Access Compliance Report

Public Rights-of-Way

Intersection ID: 48462	Main Street: PANGLEMONT_DR	Cross Street: MITZI_DEBORAH_LN	Location:	S
ADA ID: 4B42ADE870EE	Ramp Type: Perp	Initial Pass/Fail: Fail	Overall Compliance: No	Severity Score: 10

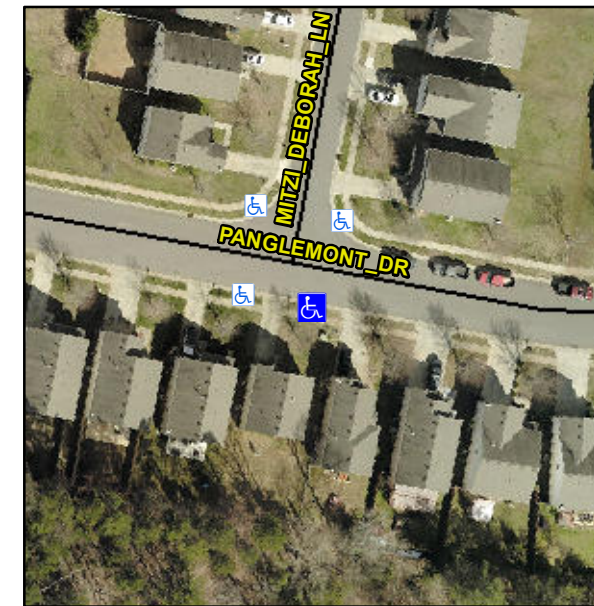
Not Found, R304.5.1, R304.5.3

Compliance	Description	Data	Compliance	Description	Data
N/A	Ramp Length (in)	47.5	Yes	Ramp Slope (%)	6.6
No	Ramp Width (in)	47.5	No	Ramp XSlope (%)	4.5
N/A	Flare Type LT	N/A	N/A	Flare Type RT	N/A
N/A	Flare Slope LT (%)	N/A	N/A	Flare Slope RT (%)	N/A
N/A	Flare Traversable LT?	N/A	N/A	Flare Traversable RT?	N/A
N/A	Landing Length (in)	N/A	N/A	DWS Provided?	N/A
N/A	Landing Width (in)	N/A	N/A	DWS Contrast?	N/A
N/A	Landing Slope (%)	N/A	N/A	DWS Length (in)	N/A
N/A	Landing X Slope (%)	N/A	N/A	DWS Full Width?	N/A
N/A	Landing Curb? (Y/N)	N/A	N/A	DWS Offset (in)	N/A
N/A	Shared Landing?	N/A			
N/A	Gutter Ponding?	N/A	N/A	Gutter Slope (%)	N/A
N/A	Gutter Lip Ht (in)	N/A	N/A	Gutter X Slope (%)	N/A
N/A	Painted X Walk1?	No	N/A	Painted X Walk2?	N/A
	X Walk 1 Direction	To NE		X Walk 2 Direction	N/A
N/A	X Walk 1 Width (in)	N/A	N/A	X Walk 2 Width (in)	N/A
	X Walk 1 Slope (%)	2.0		X Walk 2 Slope (%)	N/A
	X Walk 1 X Slope (%)	3.8		X Walk 2 X Slope (%)	N/A

Remove & Replace Entire Ramp.
